**DATE:** December 12, 2019

**RE:** #Case PL2019-220 – Creekview Office Parking Lot – 7109 West 78<sup>th</sup> Street

**Figure 1 – Parking Area Encroachment into Shore Area**

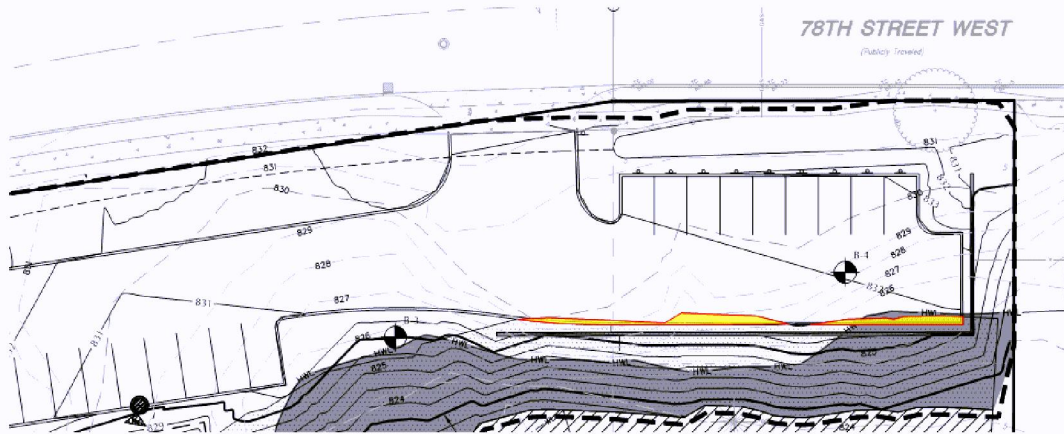
In evaluating the applicant's plans to construct a surface parking lot to serve the existing office building, staff has concluded that no reasonable alternative that does not impact the shore area exists for the location of the surface improvement. The encroachment of the surface parking area into the shore area is minimized, limited to approximately 190 square feet in the southeast corner of the parking area – see highlighted area in Figure 1. The proposed location for the parking area is the only location on site that additional parking areas can be constructed. The existing parking lot to the south and west of the office building is fully-utilized from a parking quantity standpoint. Additional parking stalls cannot be installed in a quantity that is equivalent or

approximate to the proposed parking area east of the building. As a result, the area east of the existing office building is the logical and reasonable location to site additional surface parking.
